From: Tan Minghua [charles_tan@126.com]
Sent: 10/7/2019 8:33:24 PM
To: James Dearth [JDearth@WhitestoneCC.com]
CC: ex02@yuandacn.com; Phil Carvelas [pcarvelas@WhitestoneCC.com]; Steven Grzic [SGrzic@WhitestoneCC.com]
Subject: Re: 084426-011-02 (Partial Submission) WT-3 Clerestory Remediation Calcs-Dwg_WSP_RAR
Attachments: Check D331G (20190828)_SS.pdf

From: Whitney, Freddy [<mailto:FWhitney@sciame.com>]
Sent: Wednesday, August 21, 2019 12:20 PM
To: James Dearth
Cc: Murphy, Ryan; Pardee, Michael
Subject: 084426-011-02 (Partial Submission) WT-3 Clerestory Remediation Calcs-Dwg_WSP_RAR

PROJECT: *City Tech Academic Building*

**STRUCTURAL CALCULATIONS
FOR
Bracket D331G
(REV.01)**

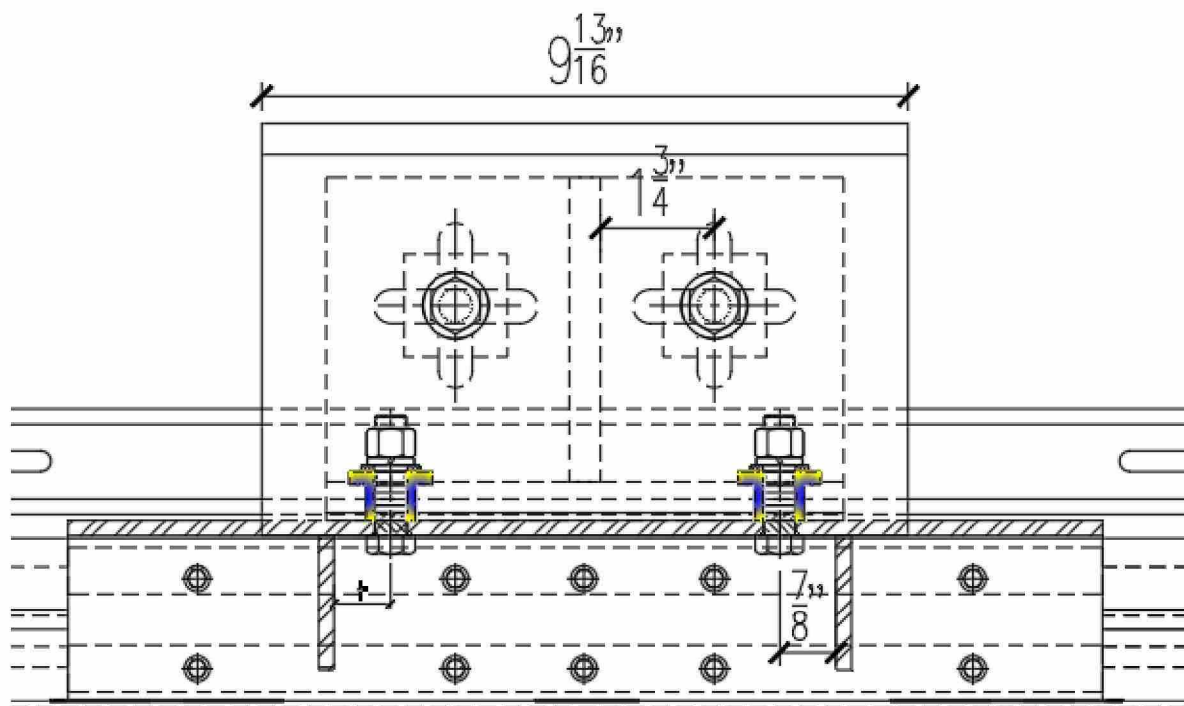
Kindly review and revise addressing all design team comments.

Please see attached reviewed submittal. It came back RAR, lets get these resubmitted ASAP.

Details and calculations have been revised already. Please review.

Check Bolt 01

$$f_{t1} := R_{w_c} \cdot \frac{\left(3 \frac{1}{16} \text{ in} + 2 \frac{7}{16} \text{ in} + 1 \text{ in} \cdot 0.5\right)}{1 \text{ in} \cdot 0.5} \cdot \frac{1}{2} = 2599 \text{ lbf}$$

$$F_t := 5676 \text{ lbf} \quad \frac{f_{t1}}{F_t} = 0.458$$

Bolt 01 checked OK

Check Bending of bracket 01

$$f_{b1} := \frac{f_{t1} \cdot \left(\frac{7}{8} \text{ in}\right) \cdot 6}{\left(\frac{7}{8} \text{ in} \cdot \tan(60 \text{ deg}) + 1 \text{ in}\right) \cdot 4 \cdot \left(\frac{5}{16} \text{ in}\right)^2} = 13.885 \text{ ksi}$$

$$F_b := 36 \text{ ksi} \cdot 0.6 \quad \frac{f_{b1}}{F_b} = 0.643 \quad \text{Checked OK !}$$
